PREPARED FOR THE PLAN COMMISSION

**Project Address:** 425 West Washington Avenue (District 4 - Ald. Verveer)  
**Application Type:** Conditional Use Alteration  
**Legistar File ID #** [38151](#)  
**Prepared By:** Kevin Firchow, AICP, Planning Division  
Jay Wendt, Principal Planner  
Katherine Cornwell, Planning Division Director  
Report includes comments from other City agencies, as noted

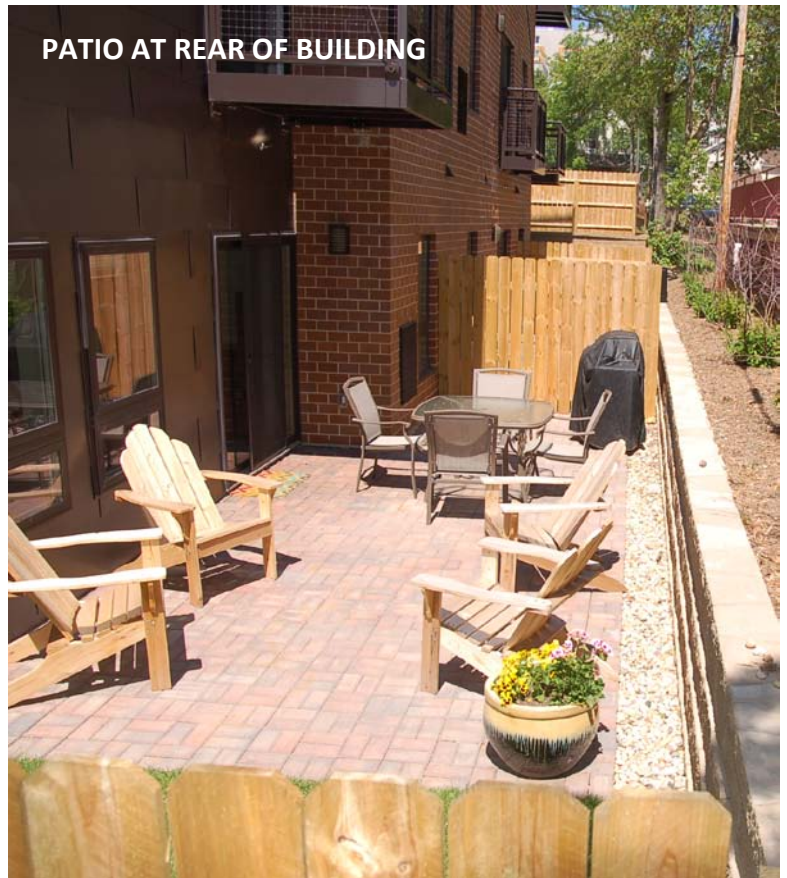
At the rear of the property (see right photo), a previously approved landscaped area has been constructed as a hard-scaped patio area for tenants. The area is covered with brick pavers. While this provides a nice tenant amenity, the Zoning Administrator has requested confirmation statistics that the project still can meet the required lot coverage requirements. The zoning code requires that lot coverage not exceed 90%. That includes buildings, accessory structures and all paved areas (with the exception of sidewalks no wider than five feet). The lot coverage requirement cannot be waived by the Plan Commission. A condition of approval is recommended that the applicant provides calculations showing code compliance.

Staff notes that most of this area sits above the subterranean parking garage. Provided this change can meet the applicable zoning requirements, the Planning Division would have supported this improvement should it have been submitted as a minor alteration.

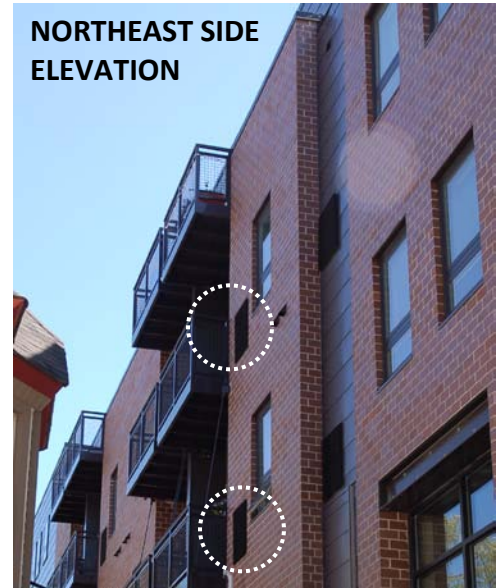
The Planning Division believes the most significant alteration relates to the revised HVAC vent locations. Plans originally had most of these vents located within balcony recesses. As noted in the below table, a majority of these have been relocated to outward-facing walls. In addition, the applicant notes that an additional HVAC vent was required to serve the commercial space. A summary of relocated vents is below:

The new and relocated vents are labeled as “2A” and “2B” on the applicant’s attached plans. The applicant states that these vents did not fit within the allowed balcony space and had to be relocated. At the time of report writing, the applicant has not shared what the cost implication would be to reconstruct these features in accordance with approved plans. Staff is also providing copies of the approved elevation drawings in the Commission’s materials. Unless specifically depicted, the HVAC vents were previously represented to be located within balcony recesses. In the below photos, examples of the non-approved, outward-facing vents are circled.

Staff notes that while there are multiple relocated vents on the building's sides and rear, none have been added to the front façade. The front façade is clearly the most visible façade. In staff's opinion, the northeast side of the building has limited visibility from the street. The southwest side, adjacent to the five-story office building is currently more visible due to orientation of that site. The Downtown Plan identifies this site as a "Potential Redevelopment/Infill Site" though there are no known plans to redevelop that property at this time.

This project was approved with an additional "bonus" story. As such, the "excess height" standard applied to this project and required a finding that the excess height allows for a demonstrated higher quality building than could be achieved without the additional stories. The Planning Division believes that aesthetically, the project better aligns with that standard as previously approved. Similarly, the Downtown Plan recommends that additional stories are to be used as a tool to encourage and reward buildings of truly exceptional design that respond to the specific context of their location and accomplish specific objectives defined for the area. The Planning Division would have recommended these vents be relocated should they have been presented like this in original plans.

The Planning Division does not believe that the standards for conditional uses are met and recommends that the Plan Commission **Place on File** the requested alteration for the relocated HVAC vents (identified in the applicant's materials as alteration "2A.") The Plan Commission is required to state the findings of fact listing the standards that have not been met and the reasons such standards(s) were not met. The Planning Division does not believe Conditional Use Standards 4, 9, 14 are met with this requested alteration. Alterations regarding the roof-top guard rail and wooden privacy fence (1A and 3A in the applicant's materials, respectively) should be carefully considered carefully against the standards.)
